Item ID: D206-667-107BL Accept ***N900040100*** Setup Start ***NS1***
Revision ID: Stop ***NS2***
Item Name: Fwd Crosstube - Mid Height 206L / L1 / L3 / L4, Blue
Start Date: 4/13/2017 Start Qty: 1.00 ***1*** Cust Item ID:
Required Date: 5/1/2017 Req'd Qty: 1.00 ***1*** Customer:
Reference: SCHEDULED/U **DAS 21 9-89**
Approvals: Process Plan: **DAS 21 9-89** Date: **APR 06 2017** Tooling: Date: Run Start ***NR1***
QC: Date: SPC (Y/N): Date: Stop ***NR2***

DART AEROSPACE LTD		Work Order: 159208
Description: Crosstube Mid Fwd (206L)		Part Number: D206-667-107
Inspection Dwg: D206-667-147 Rev: A		Page 1 of 1

DART AEROSPACE LTD HAWKESBURY, ONTARIO, CANADA	
DRAWING NO. D206-667-147	REV. A SHEET 1 OF 4
TITLE CROSSTUBE ASSY (206L MID FWD)	SCALE NTS

DART AEROSPACE LTD ENGINEERING ORDER	D.E.O. NO. D206-667-147-A-1	SHEET NO. SHEET 1 OF 1	SCALE NTS
REV. A	CROSSTUBE ASS'Y (206L MID FWD)	D206-667-147	DRAWING NO.
DATE 11.07.20	CHECKED ASS	DATE 11.07.21	DATE 11.07.21
MFG. APPR. <i>[Signature]</i>	APPROVED <i>[Signature]</i>	DE APPR. <i>[Signature]</i>

DETAIL P
BONDING STRAP INSTALLATION 2 PL

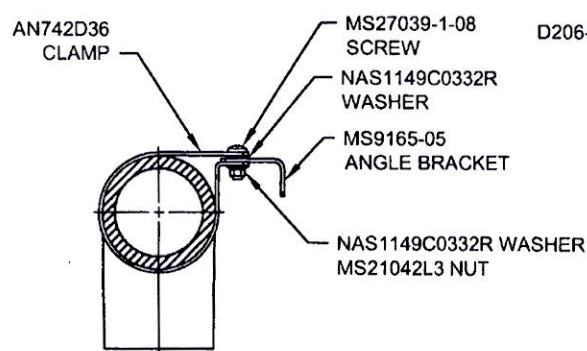
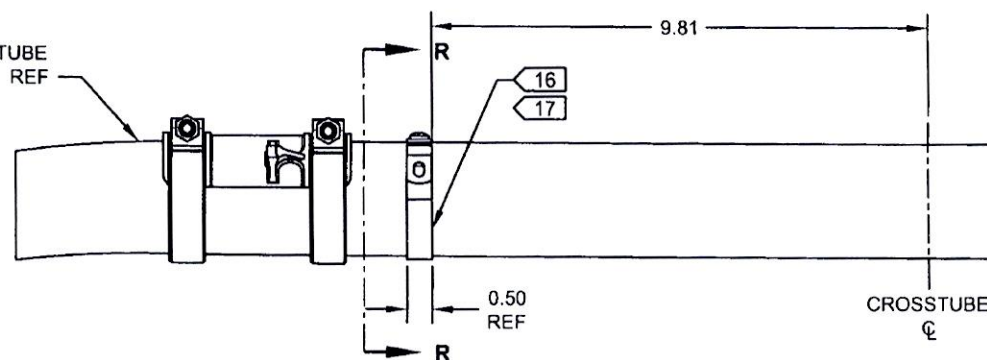
PURPOSE:

ADD ELECTRICAL GROUNDING STRAP

ITEM	QTY -147	PART NUMBER	DESCRIPTION	
1	X	D206-667-147	CROSSTUBE ASSEMBLY (206L MID FWD)	
10	2	AN742D36	CLAMP	} ADD
11	2	MS9165-05	ANGLE BRACKET	
12	2	MS21042L3	NUT (OR MS21042-3)	
13	2	MS27039-1-08	SCREW	
14	4	NAS1149C0332R	WASHER (OR AN960C10L)

- 16) MASK AREA UNDER CLAMP PRIOR TO PAINTING
17) SEAL EDGES WHERE AN742D36 CLAMP MEETS WITH THE CROSSTUBE USING SIKAFLEX-241/-291 OR MIL-S-8802 CLASS B2 OR PROSEAL 890 SEALANT
18) PERFORM RESISTANCE CHECK TO ENSURE MAX RESISTANCE IS 10 MILLIOHMS
- AFT
